**Re: NOVA Gas Transmission Ltd. (NGTL)
2017 NGTL System Expansion Project (Project)
GH-002-2015 Report
Appendix III, Condition 7 – Revised Caribou Habitat Restoration &
Offset Measures Plan
NEB File: OF-Fac-Gas-N081-2014-20 02**

REVISED CARIBOU HABITAT RESTORATION AND OFFSET MEASURES PLAN

2017 NGTL SYSTEM EXPANSION PROJECT

Table 1-1: Revision Log - Revised CHR&OMP

Figure 3-3 Access Control Decision Framework

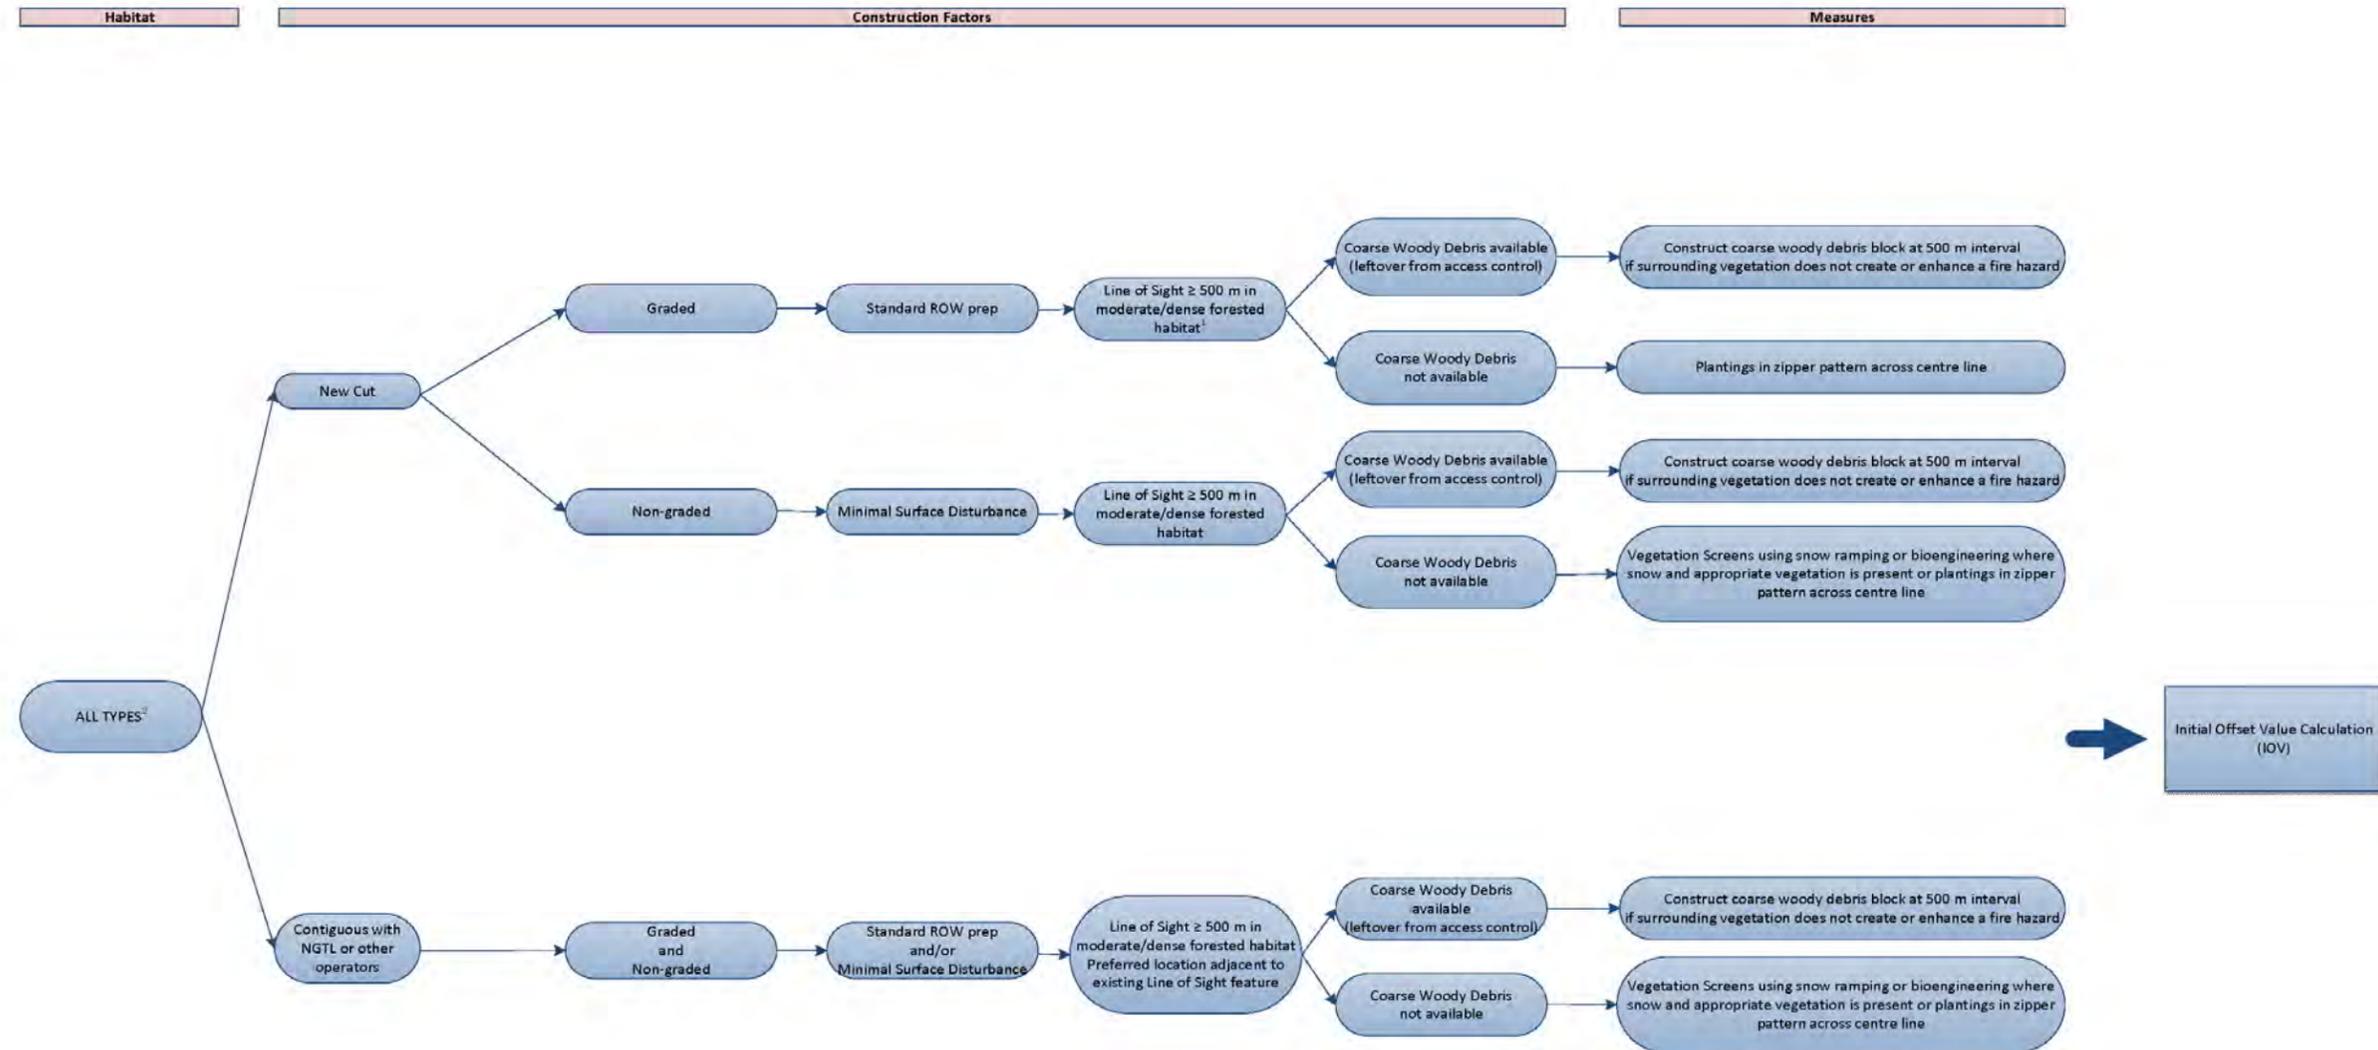
3.5	3-11	Update of decision frameworks	Access control revised to address snow ramping and extension of bores as options. Line-of-sight content revised to reflect measures more accurately. Habitat restoration updated to clarify measure options and to remove grading from wetlands. All frameworks revised to illustrate progression to Initial Offset Value calculation stage.

Figure 4-3 Offset Measures Decision Framework

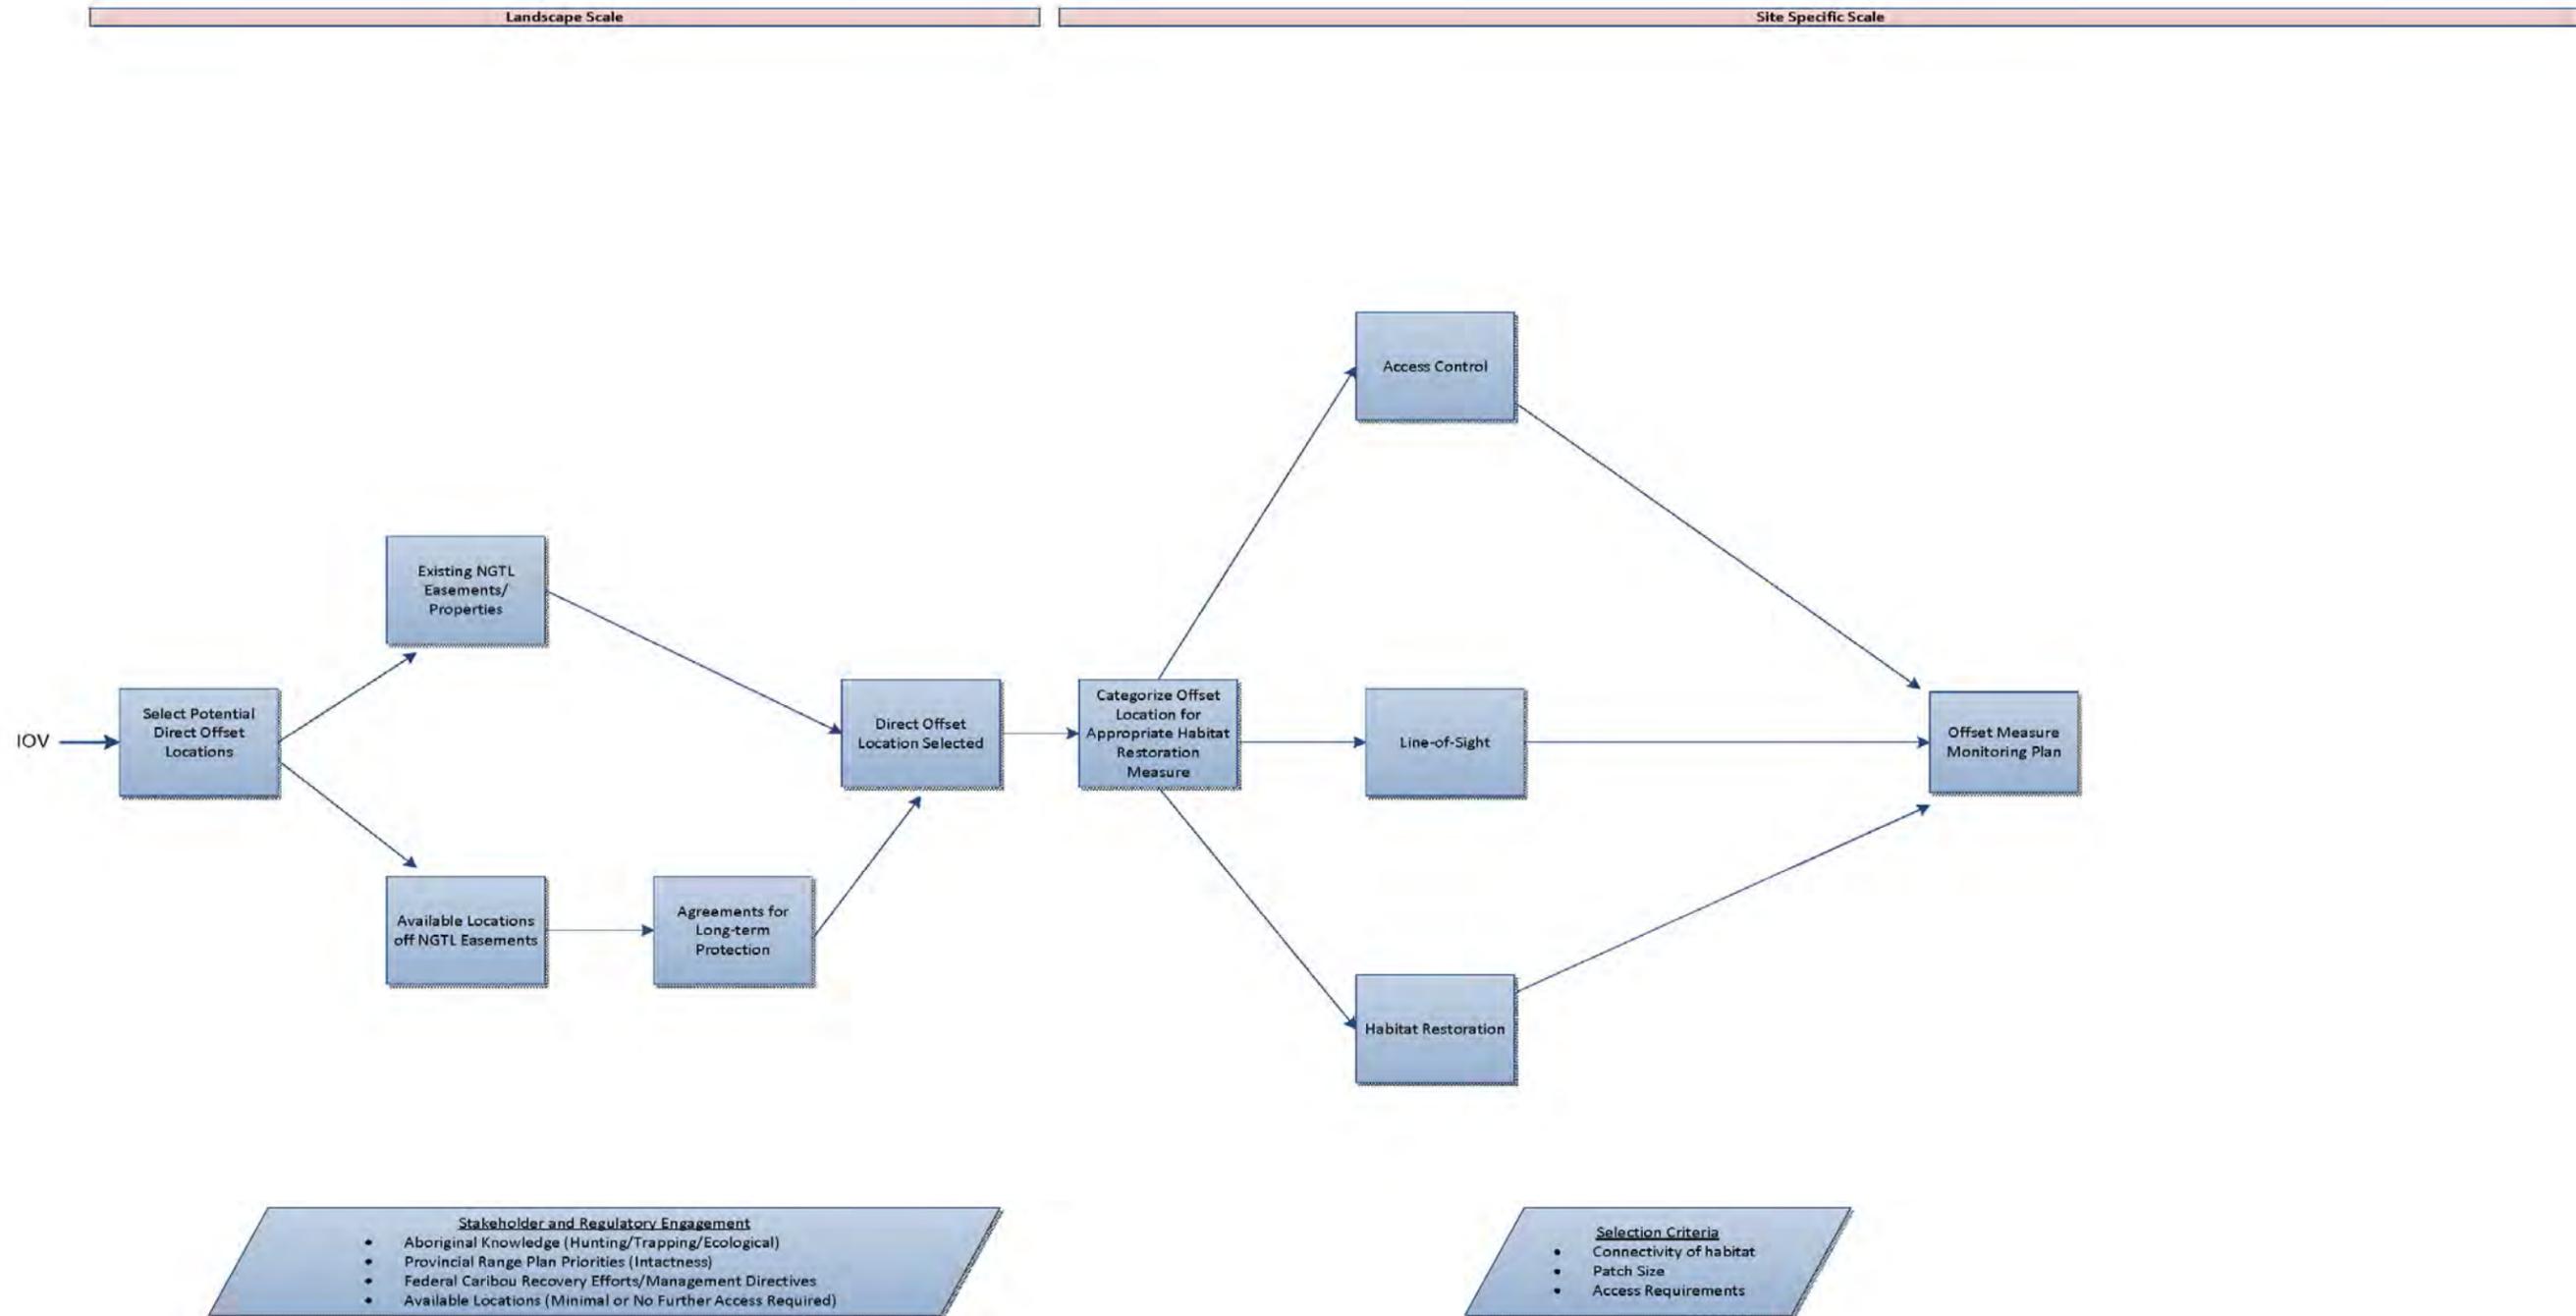
4.6	4-14	Minor edit	Correction to figure citations
4.7	4-14	Figure 4-3 updated	Figure modified to clarify landscape and site specific scale considerations, as per the filed response to NEB IR 4.21. Details of potential measures were removed as offset scenario is evaluated at the habitat unit level and is not necessarily comparable to a post-construction scenario in terms of material availability.

NEB Information Request	Topic	Requested Information	Correlation to Revised Content in CHR&OMP
4.21	Caribou and Caribou Habitat – Boundary Lake and Pelican Lake Sections - Offset Location Criteria	Clarification regarding offset location selection and Offset Measures Decision Framework	See additional content in Section 4.5.1 (Offset Location Criteria), and updated Figure 4-3 (Offset Measure Decision Framework)
